### **Addendum 43: Regulation No. 44**

#### **Revision 2 – Amendment 1**

### **Uniform provisions concerning the approval of restraining devices for child occupants of power-driven vehicles ("Child Restraint Systems")**

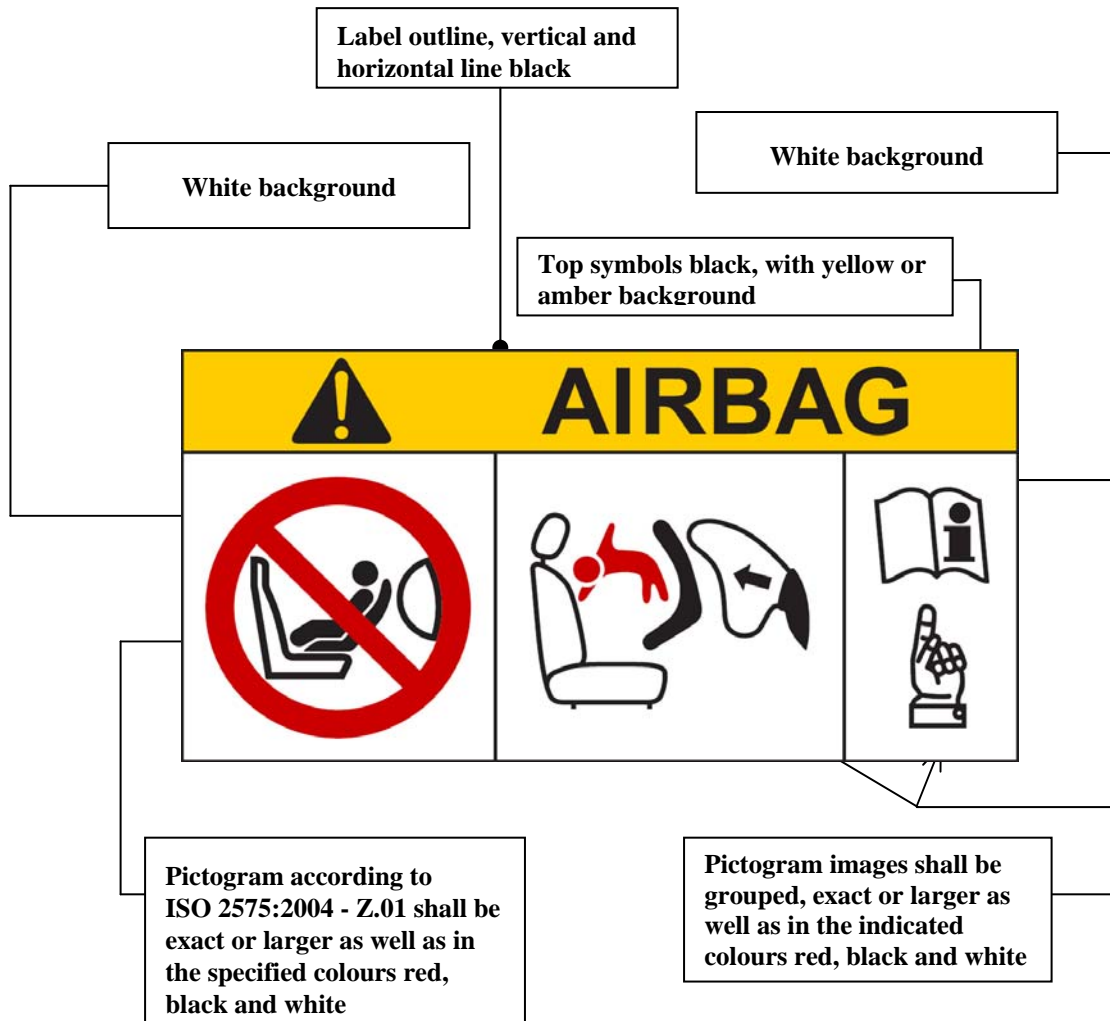
Paragraph 4.4., shall be deleted

Insert a new paragraph 4.4., to read:

"4.4. On the visible inner surface (including the side wing beside the child's head) in the approximate area where the child's head rests within the Child Restraint System, rearward facing restraints shall have the following label permanently attached (the information shown is a minimum).

Label minimum size: 60 x 120 mm.

The label shall be stitched to the cover around its entire perimeter and/or permanently bonded to the cover over its entire back surface. Any other form of attachment that is permanent and not liable to removal from the product or to becoming obscured is acceptable. Flag type labels are specifically prohibited.

If sections of the restraint or any accessories supplied by the Child Restraint System manufacturer are able to obscure the label an additional label is required. One warning label shall be permanently visible in all situations when the restraint is prepared for use in any configuration.

"4.8. ISOFIX Marking

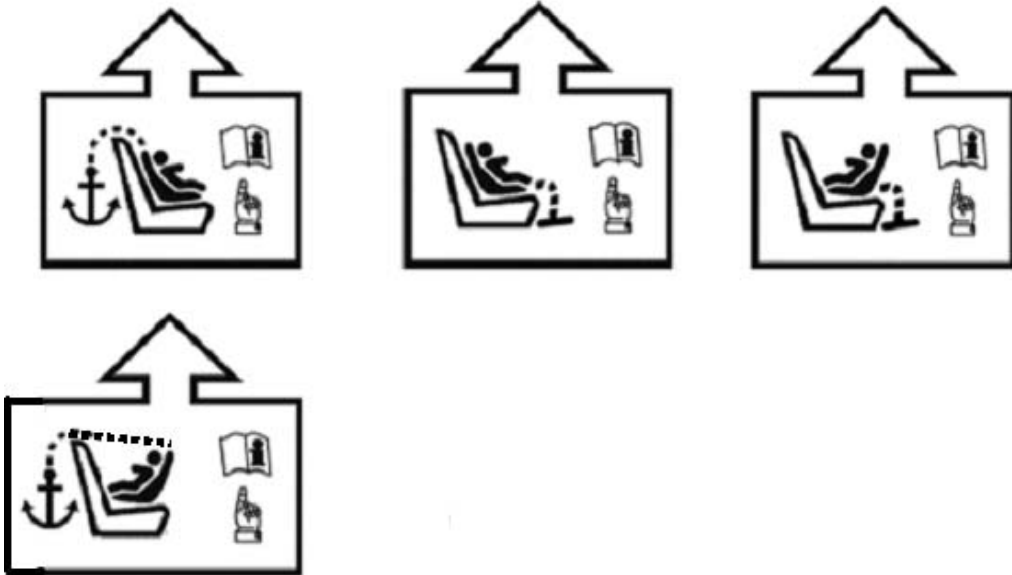
Paragraph 4.8., amend to read:
